SERVICE BULLETIN

Product : LCD Monitor	Bulletin No. : 01-C/M-E0018
Model : SyncMaster 150MP,170MP	Bulletin Date : 21.March.2001
Buyer :	ECN Date : 03. July. 2001
SUBJECT : Remote controller change for 150MP,170MP(ML15*,ML17*) LCD Monitor

Before code change

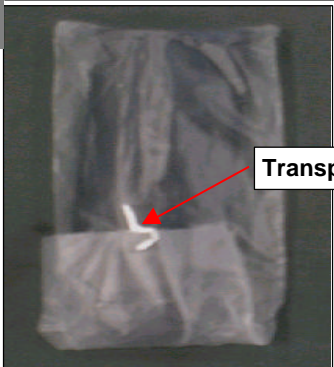
Background : When using remote controller(Remocon) of 150MP & 170MP model, can affect Samsung air conditioner to abnormal operation.

Samsung changed remote controller to prevent interference from 03.July.2000

Old type -> Design change -> Code change to prevent interference

(Add green sticker on inside battery cover)

Cause : Used same custom code with Samsung airconditioner remote controller.

Solution : In case of replacing main board for the units which produced before July.2000, replace remocon with new type.
